# NRC Staff Review of NEI/EPRI Reports On Creep And Fracture Toughness Of Zircaloy SNF Cladding

**NRC/NEI Meeting**

**April 18, 2001**

**NRC Staff Review of  
NEI/EPRI Report On Fracture  
Toughness Data For Zirconium Alloys –  
Application To Spent Fuel Cladding In  
Dry Storage**

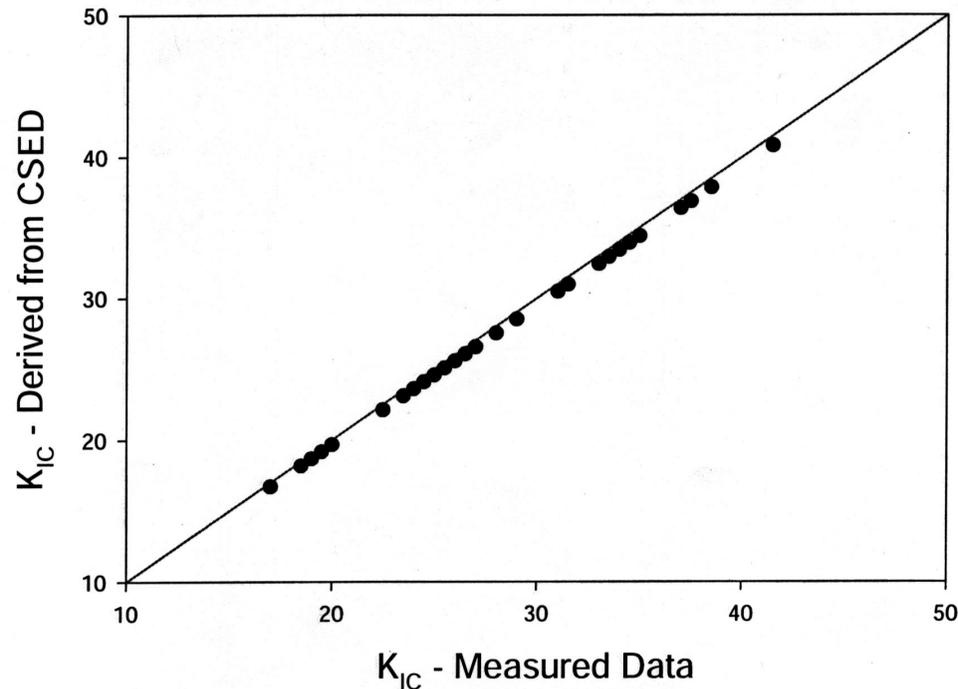
**7. The total strain energy,  $U_c$ , in equation (13) should be divided by crack length (or, crack area?); otherwise, an imbalance in units exists. However, questions still persist with respect to the adjustable constant, 3.5, which depends on the factor ‘r’ and its interpretation.**

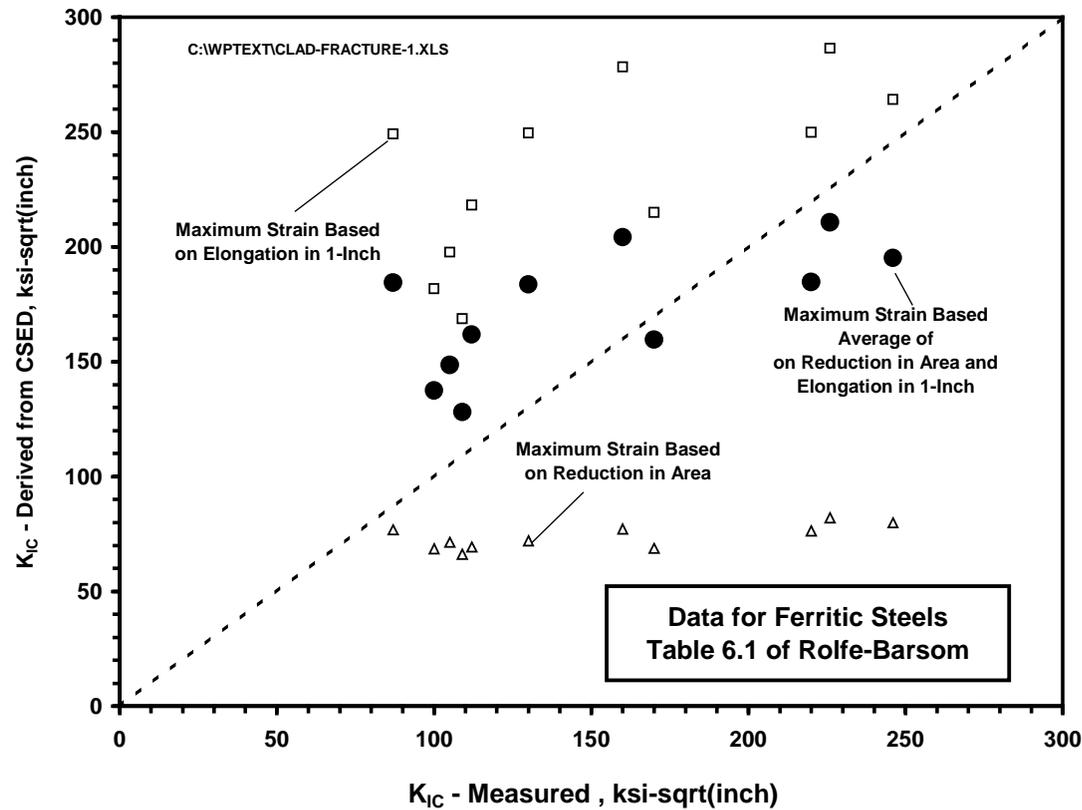
**10. When CSED approach was applied to ferritic steels, predicted and measured toughness values differed by a factor of 2.**

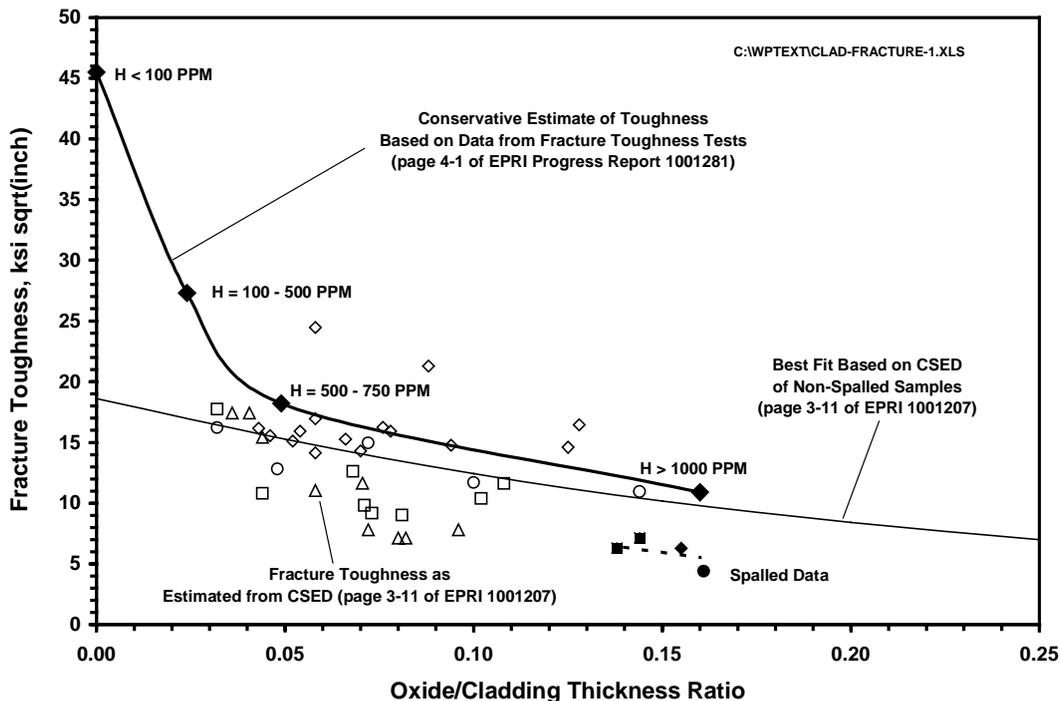
12. Re-casting the data provides some useful information, although large uncertainties still pertain. In general, CSED estimates seem more conservative.
